U. S. ATOMIC ENERGY COMMISSION
REGION I
DIVISION OF COMPLIANCE

Report of Inspection

CO Report No. 247/69-9

Licensee: CONSOLIDATED EDISON COMPANY
Indian Point No. 2 (IP-2)
License No. CPRR-21
Category B

CONSOLIDATED EDISON CO.
CO REPORT No. 247/69-9
APPENDIX B

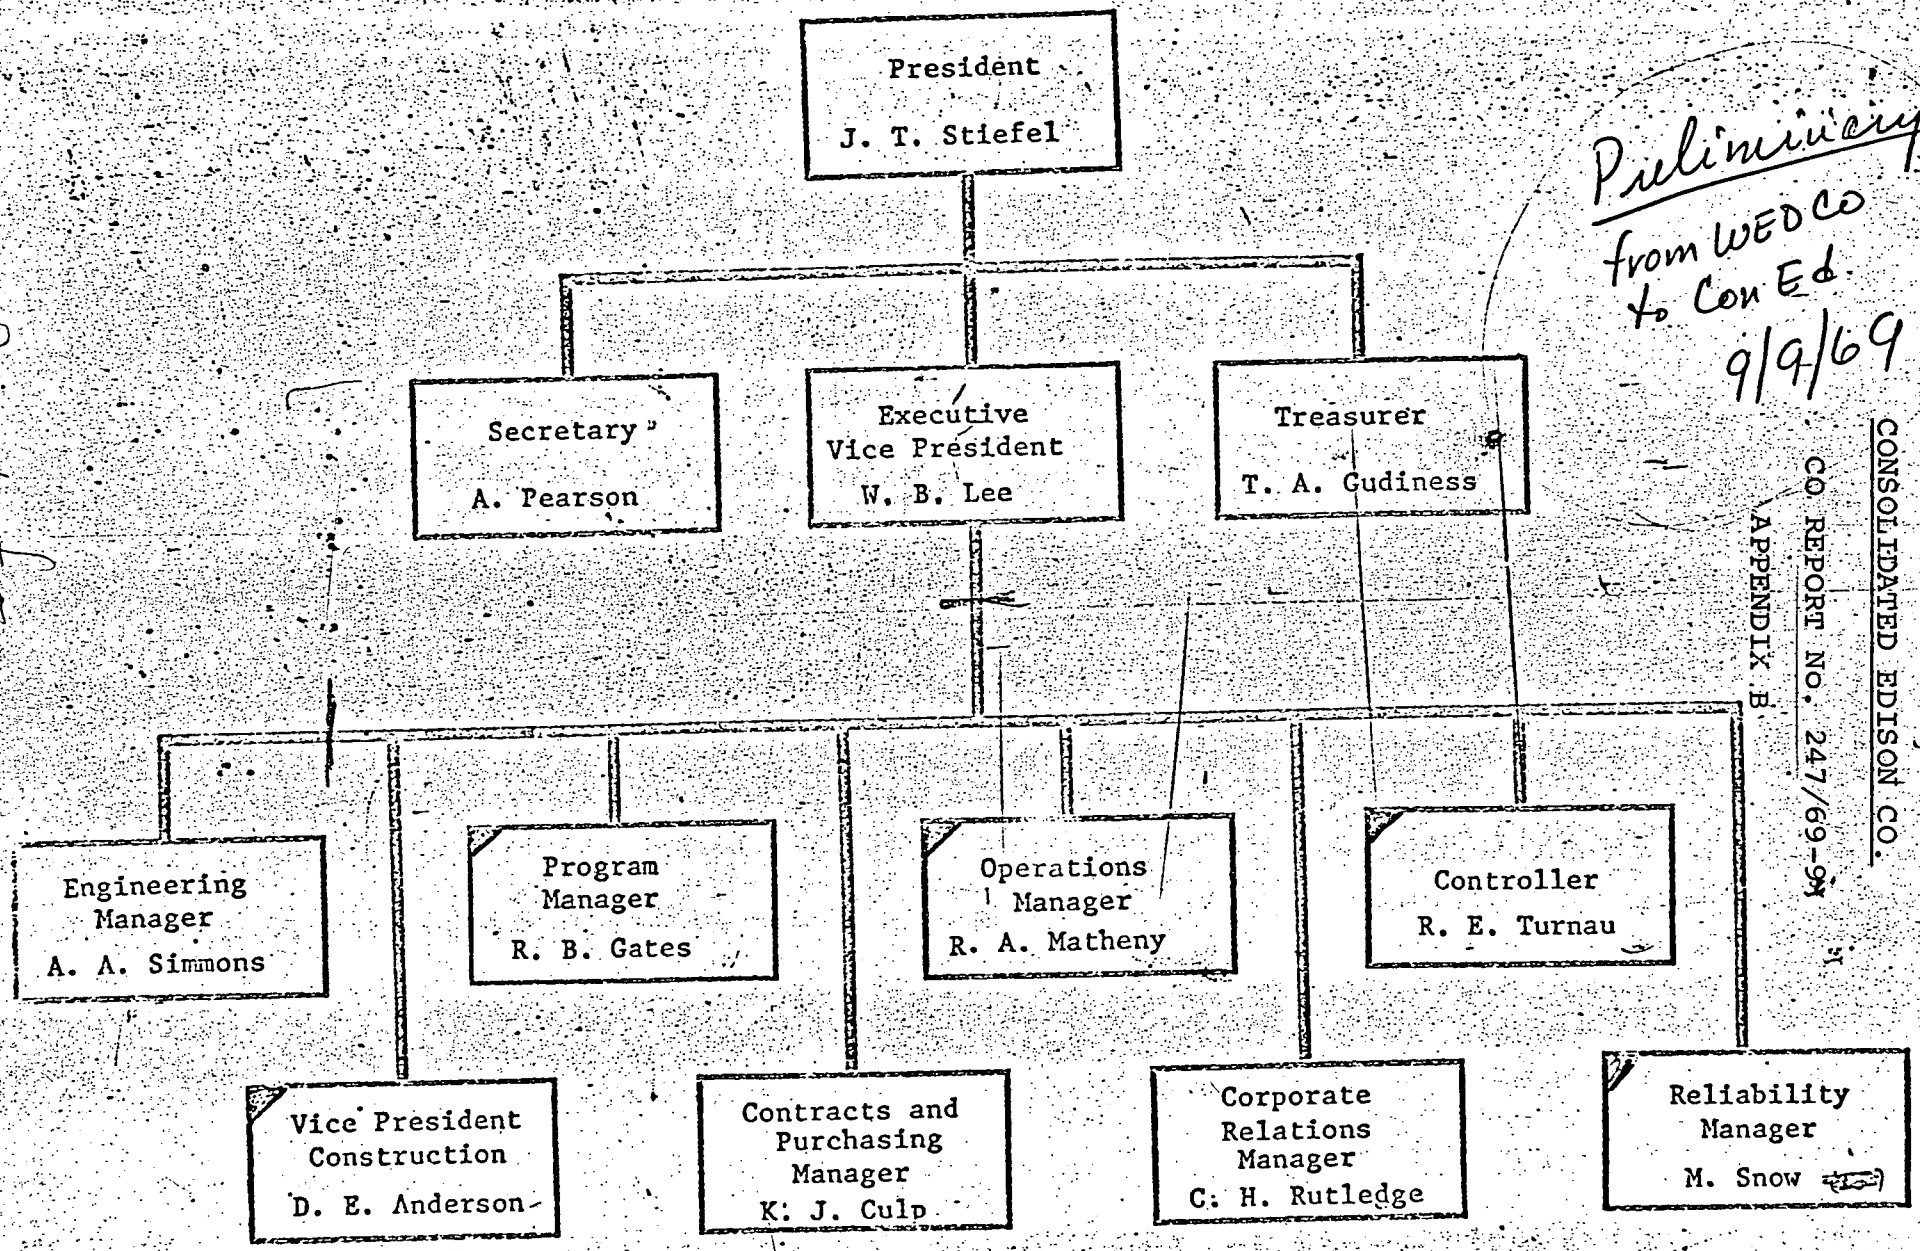
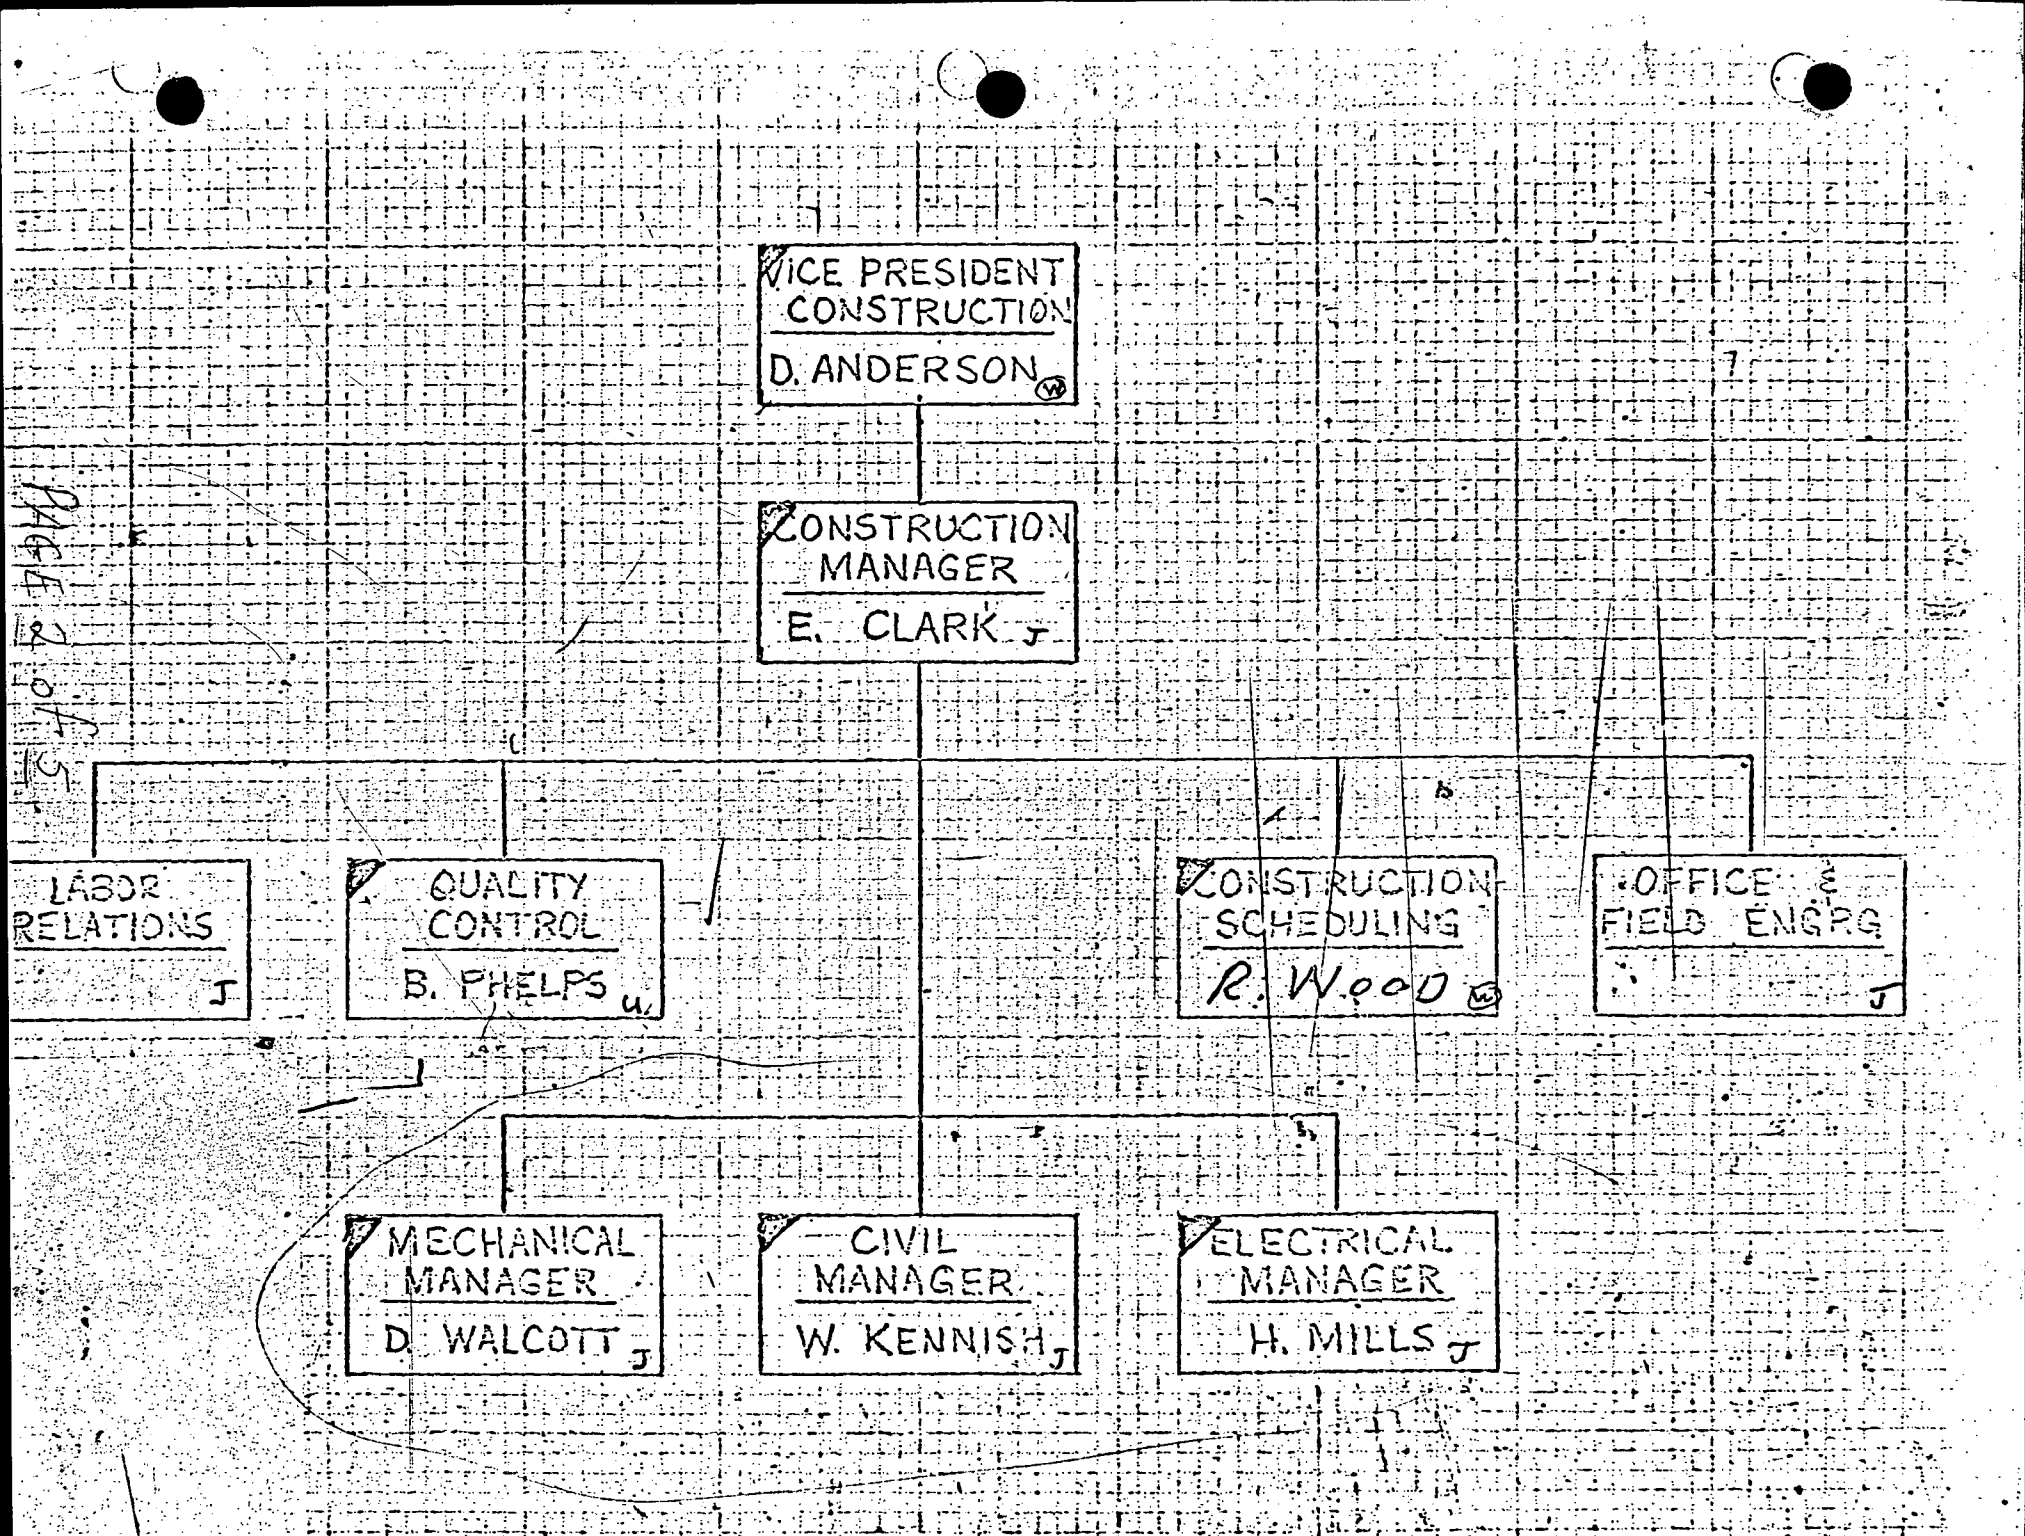
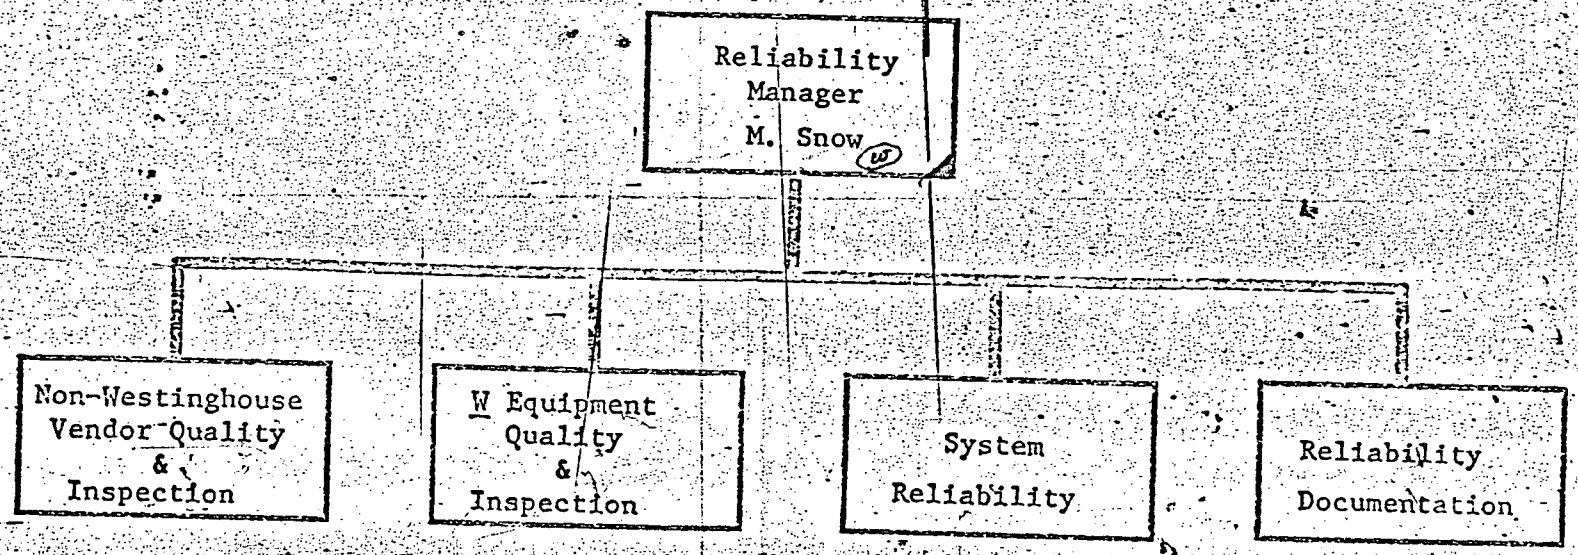
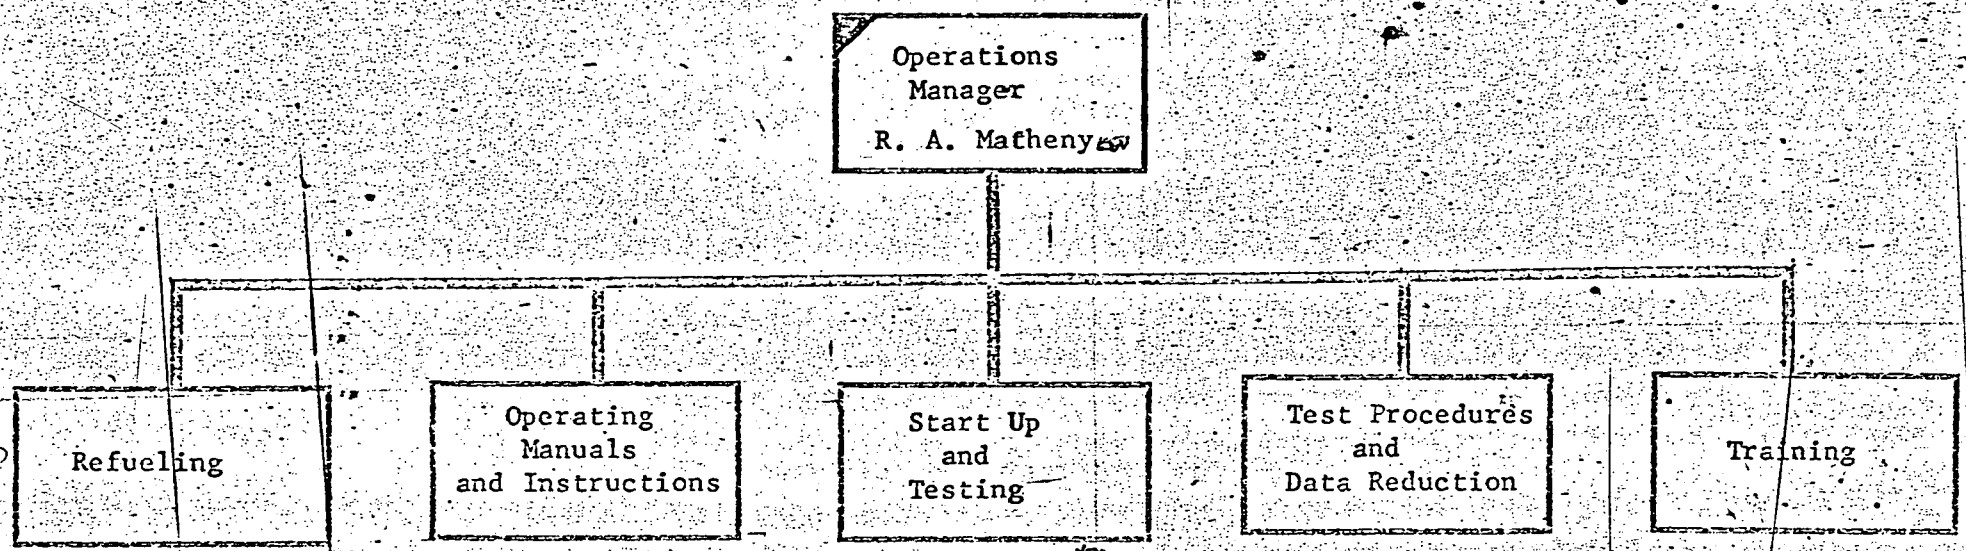
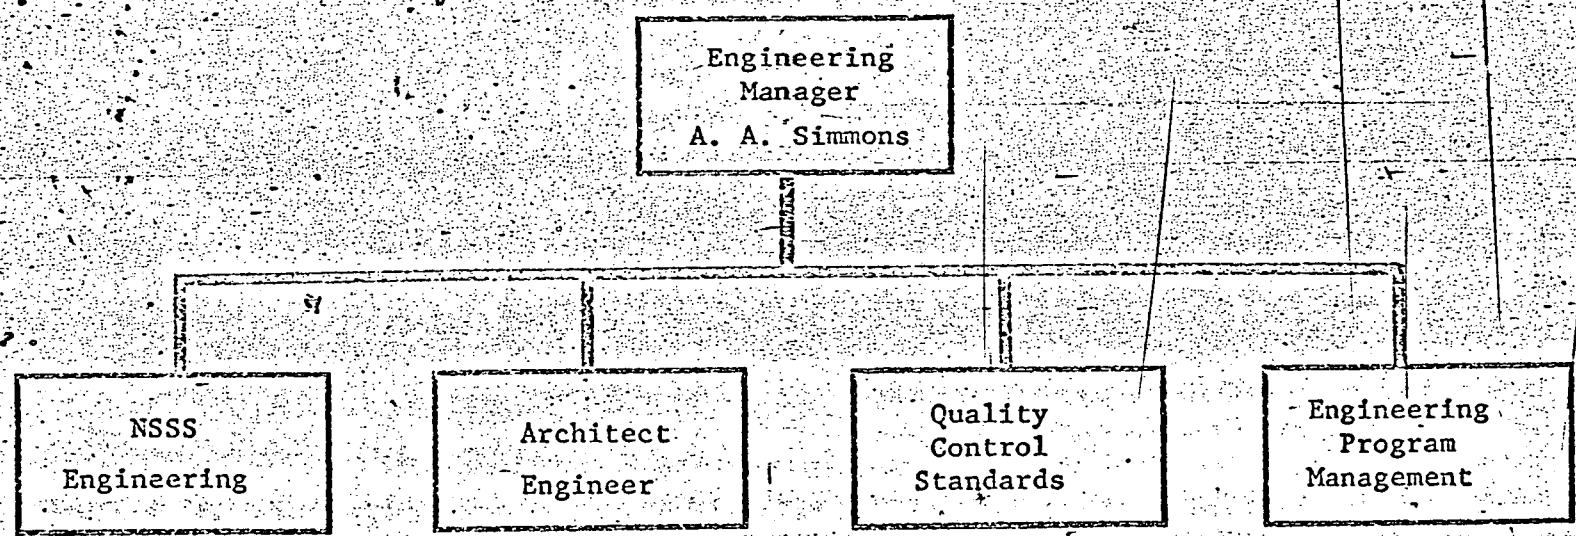
The review of the proposed organization presents the following items of concern to the inspector:

(1) The departure of UE&C and establishment of Wedco is contrary to the organizational coverage for construction and quality control as specified in various places throughout the FSAR.

(2) It appears that one level of quality assurance is eliminated for site construction activities. In addition the construction quality control group reports to the Construction Manager.

(3) The potential is for a letdown in individual efforts as a result of impending departure from the job, loss of job continuity and failure to fully followup on previously identified problems.

(4) The apparent difficulty in acquiring the desired types of personnel may lead to insufficient coverage.

(5) The organization change will result in preoperational and operating procedures being available at a later date than previously planned.

Con Ed is following the proposed transition on a daily basis. Upon inquiry, Mr. McElwee stated that Westinghouse had given assurance that an orderly transition would be made and that every effort would be made to prohibit any decrease in construction quality. He informed the inspector of Con Ed's obvious concerns relating to organizational changes and potential losses in construction progress. Mr. Corcoran stated that the Compliance inspector will be kept informed of the organization change status.
